**ADDENDUM NO. 1**  
**Issued February 4, 2016**

**Howell City Offices Wall Repair**  
**City of Howell, Michigan**

# PARTIAL THIRD FLOOR FRAMING PLAN

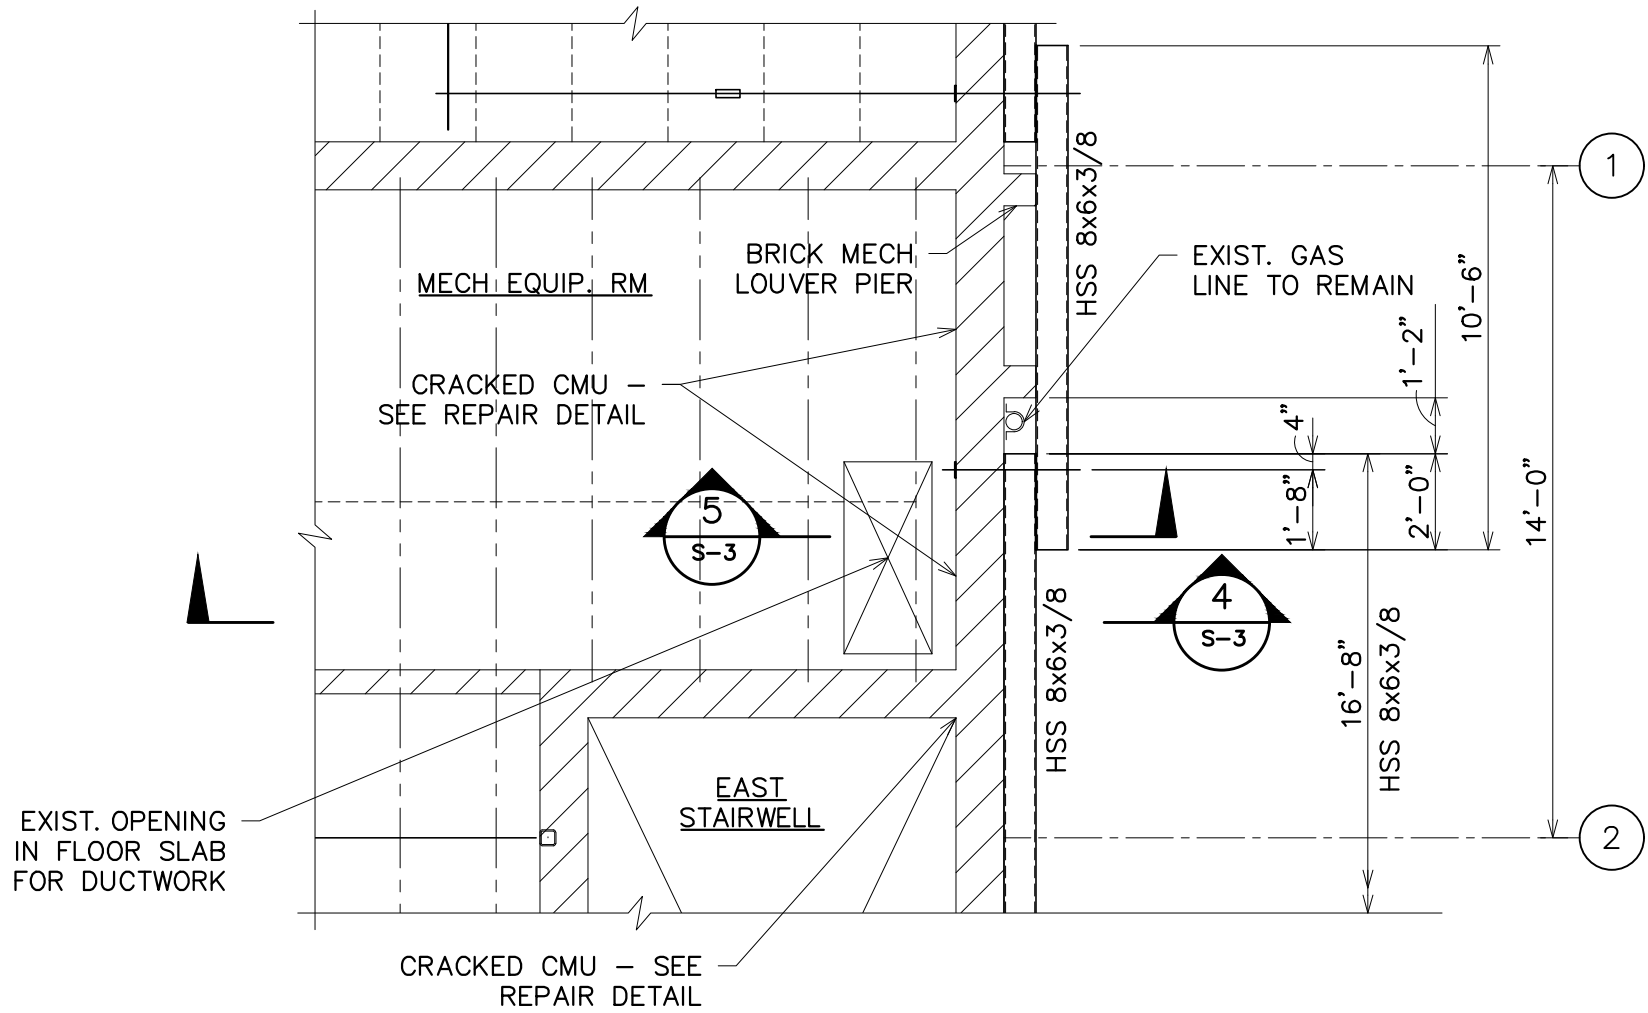
- There was an inquiry regarding the following note on Sheet A-2: "Existing conduit, gas line, lighting and security devices etc. are to be removed and reinstalled around new steel at facade as required to accommodate installation." It was discussed that the Prospective Bidders' general preference was to avoid working with the gas line.

**Response: Revisions to the dimensions of the HSS 8 x 6 x 3/8" pieces located on the exterior of the east façade have been made in the vicinity of the gas line. See attached sketch SK-1 for an enlargement of the "Partial Third Floor Framing Plan" (Second Floor Similar).**
